Modification Recommended Service Note

P5001B Keysight Streamline Vector Network Analyzer

Potential lifted front panel overlay

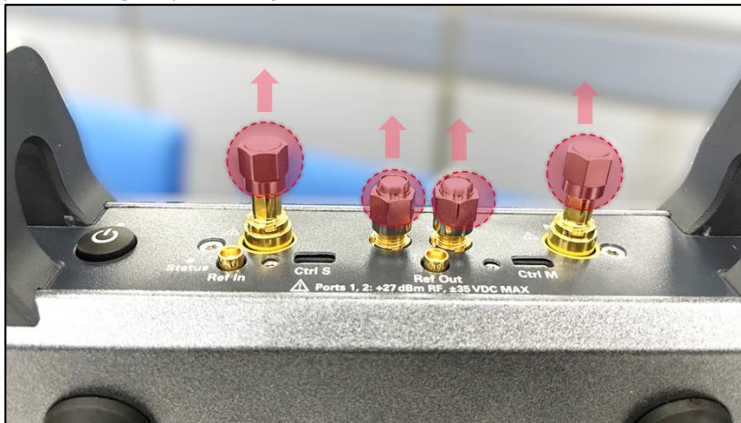
Keysight streamline series vector network analyzer (VNA) of serial number range identified in service note cover page might potentially exhibit the following lifted front panel overlay symptom.

Apart from cosmetic imperfections, the lifted front overlay could have led to non-fully attached *Ctrl S* micro-HDMI cable connector in multi-VNAs setup configuration.

-> Apply this service note only if end users' VNA is exhibiting the following symptom.

Procedure to replace the front panel overlay.

1. Remove the front handles. Detach the 50-ohm termination (LO-In, LO-Out, Port 1 & Port 2) or protecting caps if they are attached to the VNA.

2. Pry open the existing front panel overlay and remove it from front panel.
3. Clean the metal surface thoroughly and ensure it is free of adhesive residue.
4. Affix the new self-adhesive front panel overlay onto the metal surface.
5. Reinstall (reuse) the 50-ohm terminations and port protecting caps accordingly.

6. Reinstall (reuse) the front handles.
